PROPOSED IMPROVEMENT INTERSECTION PROJECT TOWN OF HARTLAND COUNTY OF WINDSOR THREE CORNERS INTERSECTION

**PRELIMINARY
 PLANS**

APRIL 2016

SHEET 1 OF 31 SHEETS

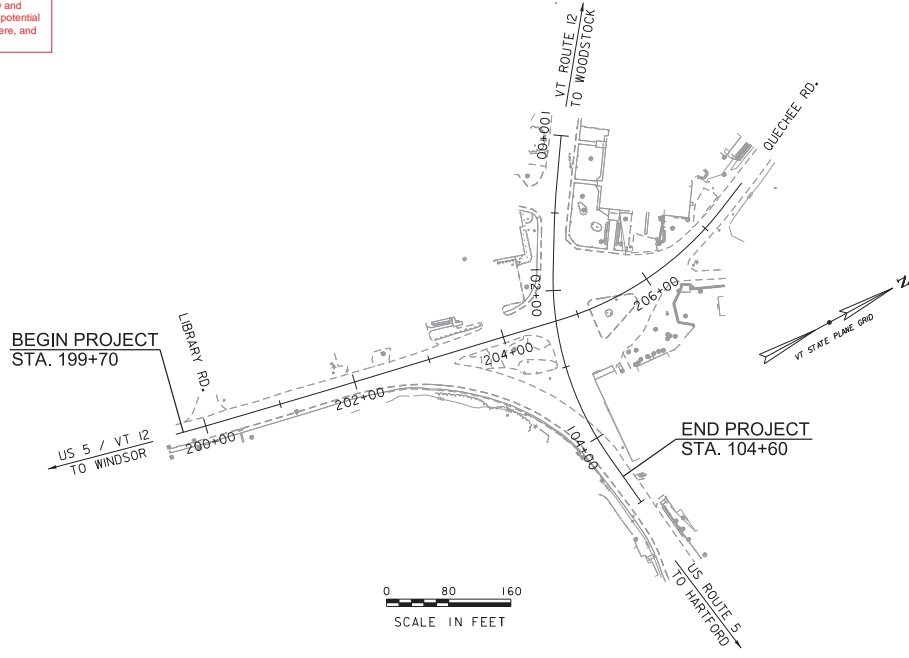
Traffic Control Plan?
 Traffic Control Notes?
 How will construction vehicles access the site?
 Access to nearby drivers and roadways will need to be accommodated.
 Please refer to the Work Zone Safety & Mobility Guidance for more information.
 The Traffic Control plan should include the following:
 General Traffic Control Notes
 Special provisions - Access to businesses and residence, etc.
 Utilizing flaggers and UFDs within the Work Zone
 Pedestrian Accommodations, Bicycle Accommodations, Emergency Vehicles, school bus, postal deliveries, trash pick-up, PCMS messages examples.
 Construction Phasing & Sequencing: (including pedestrian accommodations where applicable)
 A layout of each phase of construction showing:
 Existing lane configurations,
 Existing traffic control devices (signs, signals, and pavement markings)
 Existing site specific features: drives, ramps, and highway intersections.
 Location of all temporary traffic control devices

Flagger and UFD locations.
 All pertinent dimensions shall be labeled -Taper lengths, temporary lane widths, and distance from existing traffic control devices
 Work Zone limitations - speed reduction, surface conditions, delay times, temporary pavement markings

District 4 is requesting that alternate configurations such as a Roundabout be explored. The multiple stop in this design still has 4 stop signs which is only one less than the current situation. For the amount of work involved in this project, the public should be given a resulting product that is much more efficient. This really looks like a roundabout for a roundabout.

The potential impacts to cultural and natural resources from a roadway realignment project would typically be sent through the Environmental Section for review and clearances, with possible permitting requirements. Projects with much less potential impact are reviewed and cleared by us; it looks like there is a lot going on here, and this is an important intersection.

PAVEMENT ROADWAY UTILITY TRENCH  
N.T.S.

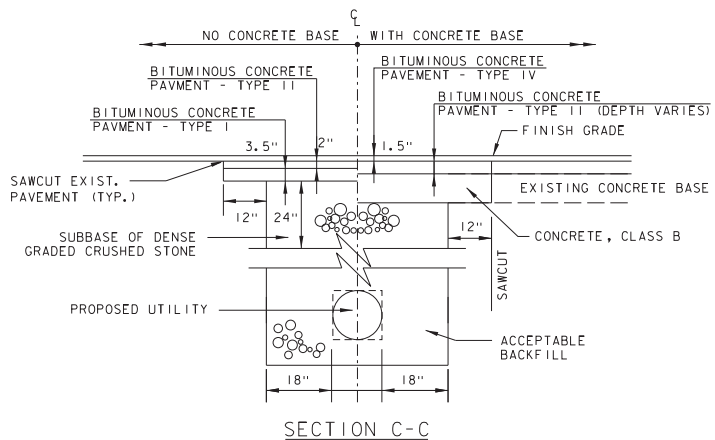
What utility trenches are there in this project? If this is intended for the drainage it should be labeled as such.

PROJECT NAME: HARTLAND	
PROJECT NUMBER: 57790.00	
FILE NAME: 57790BDR.AL1.dgn	PLOT DATE: 4/22/2016
PROJECT LEADER: J.D. SALADINO	DRAWN BY: O.M. DARISSE
DESIGNED BY: O.M. DARISSE	CHECKED BY: D.M. PECK
ROADWAY LAYOUT (1 OF 2)	SHEET 13 OF 31

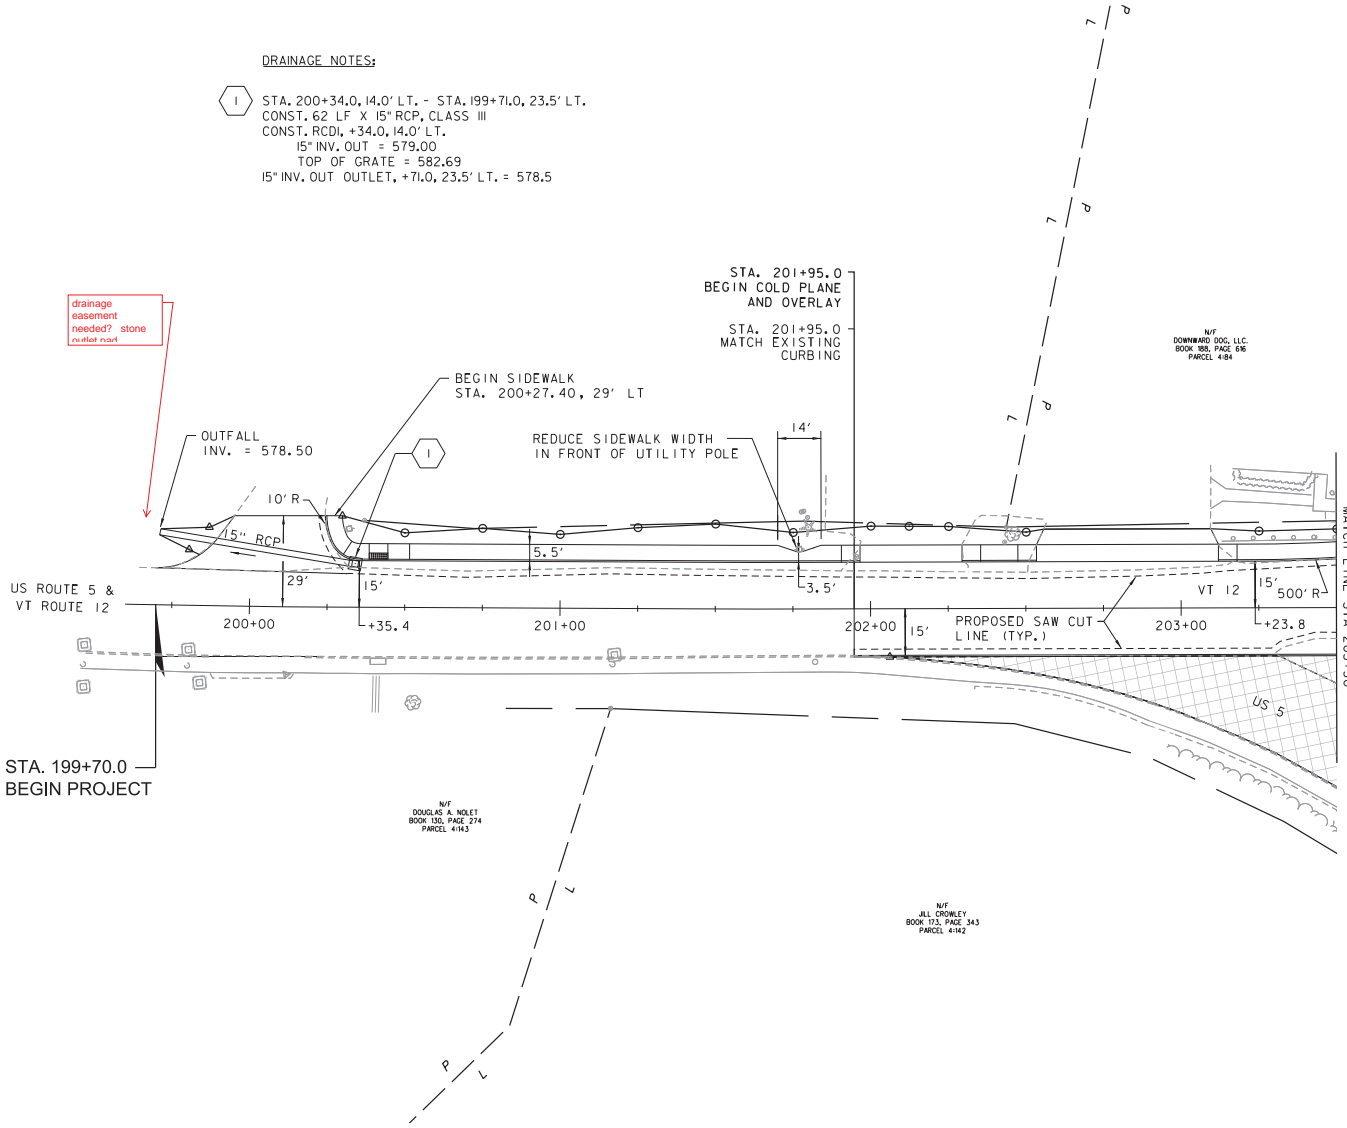
drainage  
 easement  
 needed? stone  
 outlet exist

PROJECT NAME:	HARTLAND	PLOT DATE:	4/22/2016
PROJECT NUMBER:	57790.00	DRAWN BY:	O.M. DARISSE
FILE NAME:	57790BDR_ALI.dgn	CHECKED BY:	D.M. PECK
PROJECT LEADER:	J.D. SALADINO	ROADWAY LAYOUT (2 OF 2)	SHEET 14 OF 31

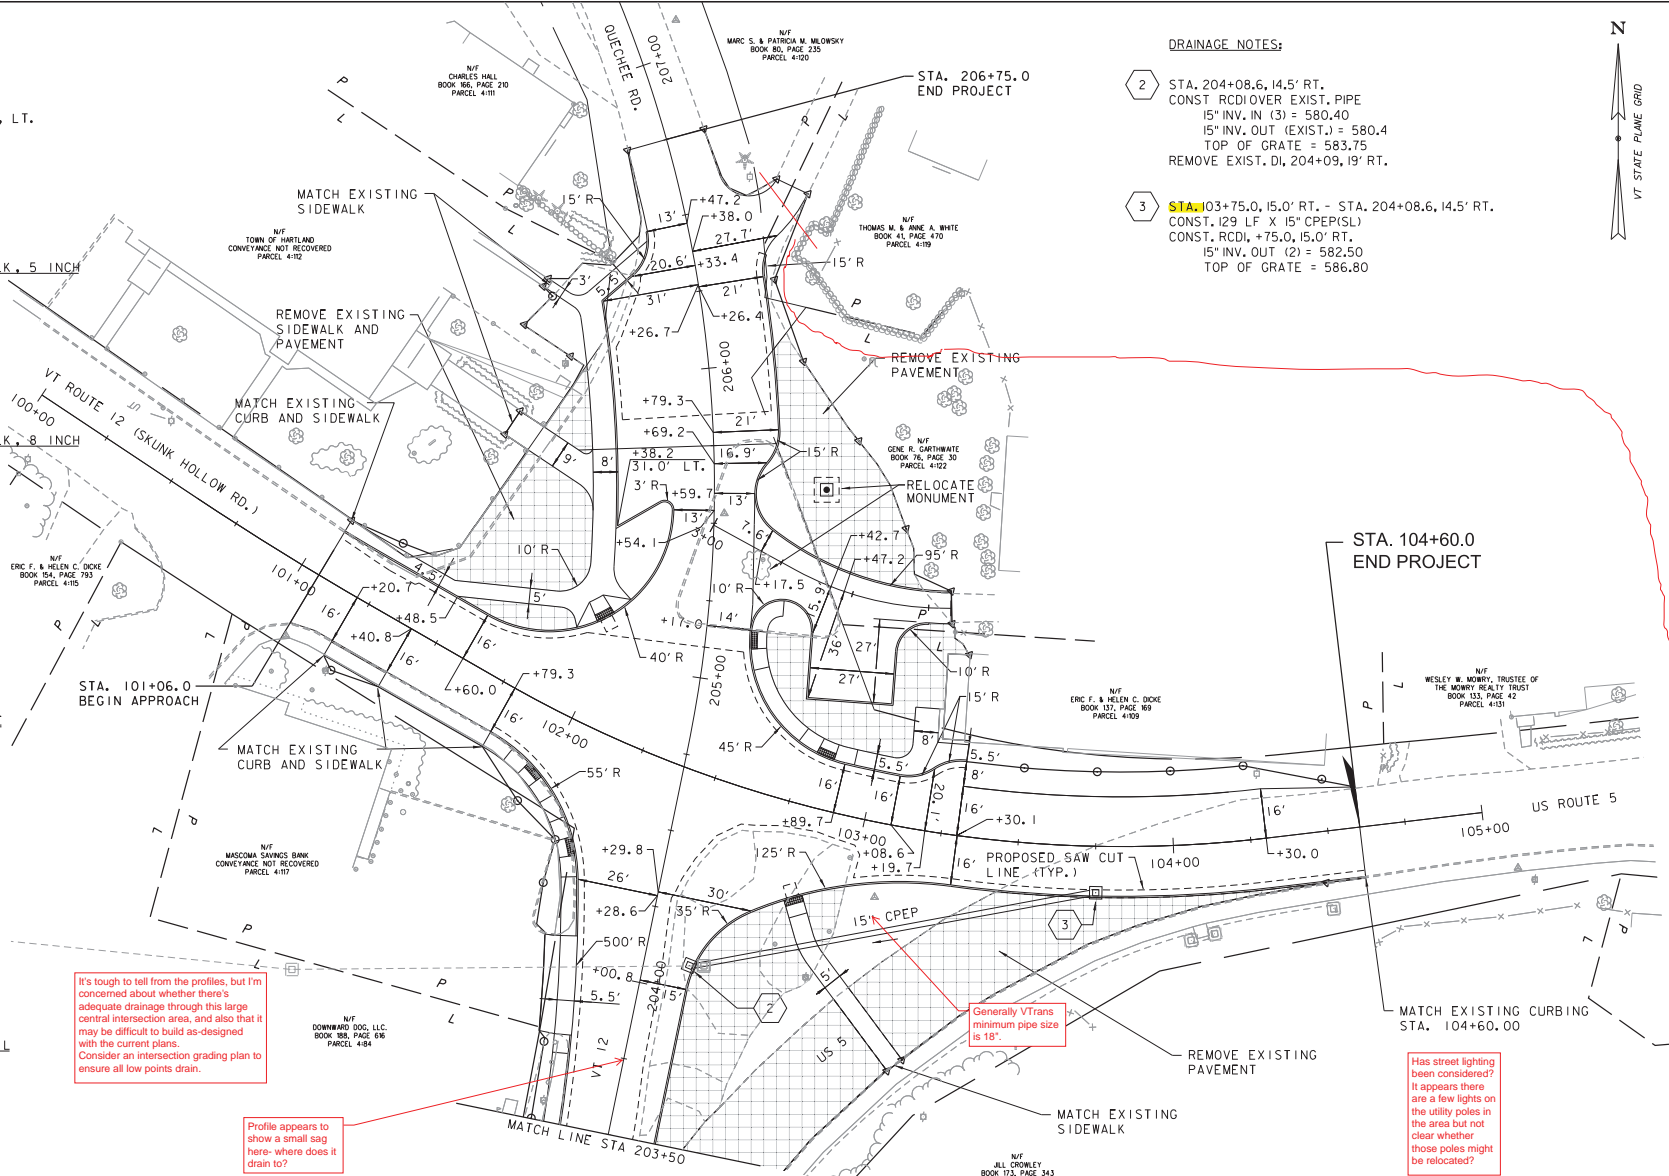
It's tough to tell from the profiles, but I'm concerned about whether there's adequate drainage through this large central intersection area, and also that it may be difficult to build as-designed with the current plans. Consider an intersection grading plan to ensure all low points drain.

Profile appears to show a small sag here - where does it drain to?

Generally VTrans minimum pipe size is 18".

Has street lighting been considered? It appears there are a few lights on the utility poles in the area but not clear whether those poles might be relocated?

FILE NAME: 57790pro.dgn  
PROJECT LEADER: J.J. SALADINO  
DESIGNED BY: O.M. DARISSE  
VT 12/US 5 PROFILE

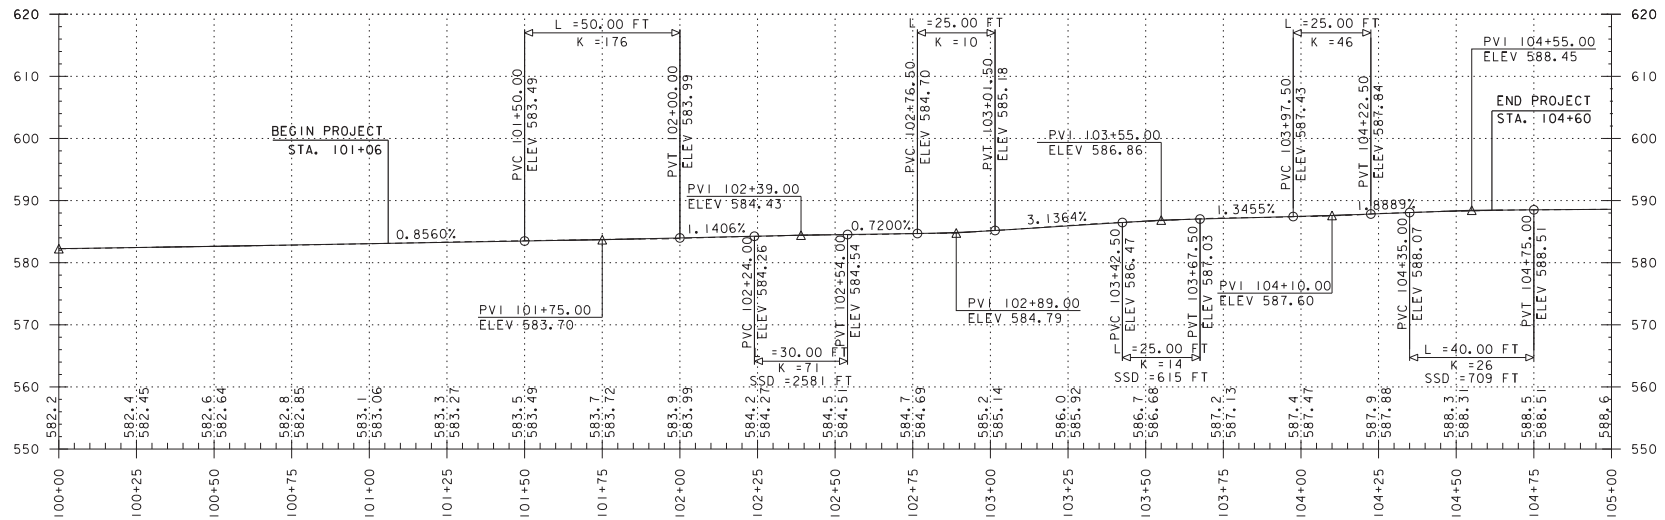
Typical section indicates cross slope varies - banking diagram?

FILE NAME: 57790BDR.SPM.dgn  
 PROJECT LEADER: J.D. SALADINO  
 DESIGNED BY: O.M. DARISSE  
 SIGNING AND STRIPING LAYOUT (2 OF 2)

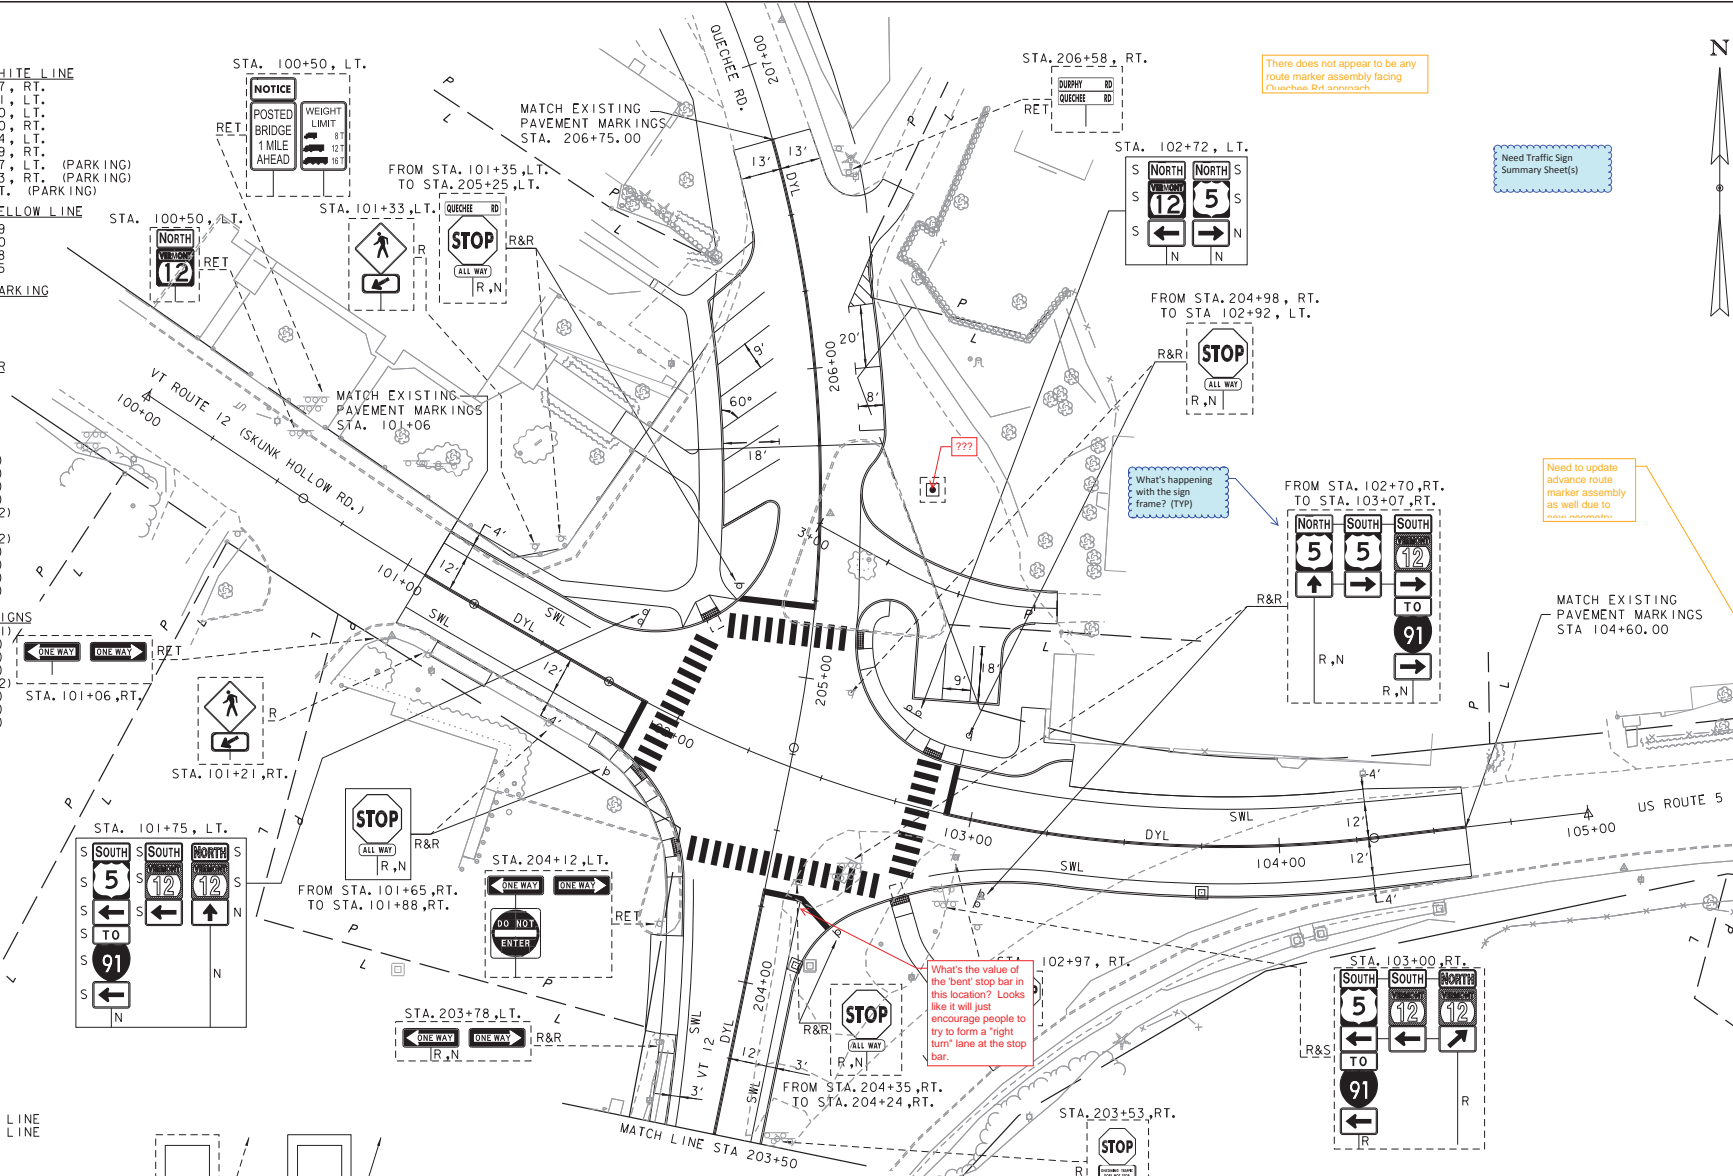
There does not appear to be any route marker assembly facing Quechee Rd approach.

Need Traffic Sign Summary Sheet(s)

Need to update advance route marker assembly as well due to recent rework.

What's the value of the bent stop bar in this location? Looks like it will just encourage people to try to form a "right turn" lane at the stop bar.

Also need a new STOP AHEAD warning sign for the NB US-5 approach. Already exists for SB US-5 and SB VT-12. Note sure about the Quechee Road approach.

What's happening with the sign frame? (TYP)
